CITY OF NOVI CITY COUNCIL SEPTEMBER 22, 2025

SUBJECT: Consideration of a Preliminary Site Plan request for Twelve Mile Townes with

a PD-2 option, a Special Land Use permit, Wetland Permit, and Storm

Water Management plan.

Figure 1. City of Novi Regulated Wetlands Map Approximate Site boundary is shown in red.

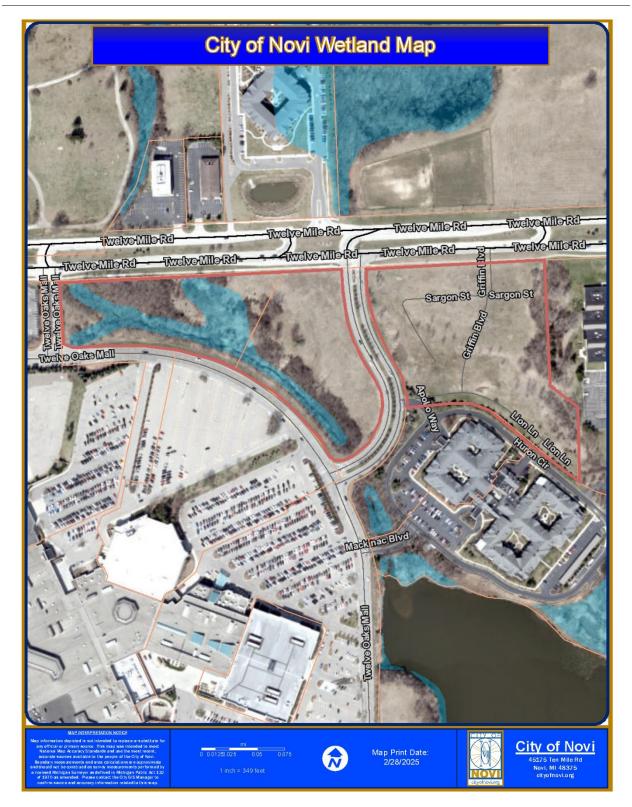
- Although no tree replacements are required on-site, it is recommended that remaining shrub and tree covered areas (identified on Figure 1) be preserved in a conservation easement for both woodlands and wetlands. If feasible, this will allow for the permanent shade cover of Bishop Creek (reducing water temperature) and continued growth of trees in this area. This may or may not benefit the proposed development in the form of additional future visual and sound screening between the existing 12 Oaks Mall and the proposed development.

Proposed approximate Future conservation easement is in yellow (does not include the recommended additional wetland conservation/enhancement area on-site).
